ZONING CHANGE REVIEW SHEET

CASE: C814-2018-0121 -- 218 South Lamar

Staff supports the Applicant's request for PUD zoning on the property, with the addition of a public restrictive covenant (RC) to attach the Transportation Mitigation Memo (Exhibit G). For a summary of the basis of Staff's recommendation, see pages 4 & 5.

4-Lane Divided, 60' Curb-to-Curb
Back-of-Curb Condition F
Barton Springs Road to Riverside Drive

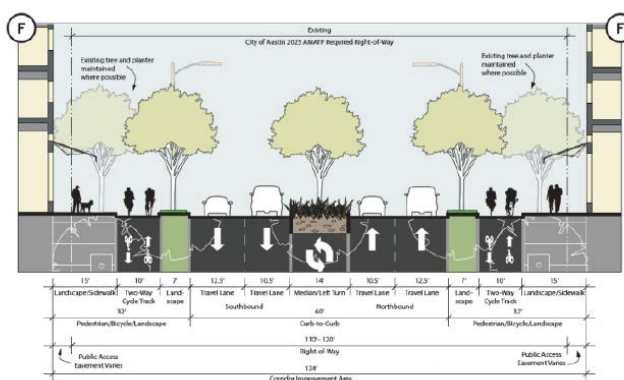
TR2. Include the below streetscape in the land use plan. Contact this reviewer for a more legible copy of it if necessary. This project is adjacent to a street that has been identified in Austin's Corridor Mobility Program (S Lamar). The sidewalk and bicycle facilities shall comply with the required cross-section at the time of the site plan application. The cross section that will be required is shown below. Find additional information about the Corridor Mobility Program here: <https://data.austintexas.gov/stories/s/Corridor-Mobility-Program/gukj-e8fh/>. Any proposed curb relocations on S Lamar requires coordination with the Corridor Planning Office and Bicycle Program. The cross section will include a 7' planting zone with street trees, a 10' two-way cycle track, and a 15' clear zone all behind curb. Additionally, a protected intersection will be required at Toomey, to be reviewed at the time of Site Plan.
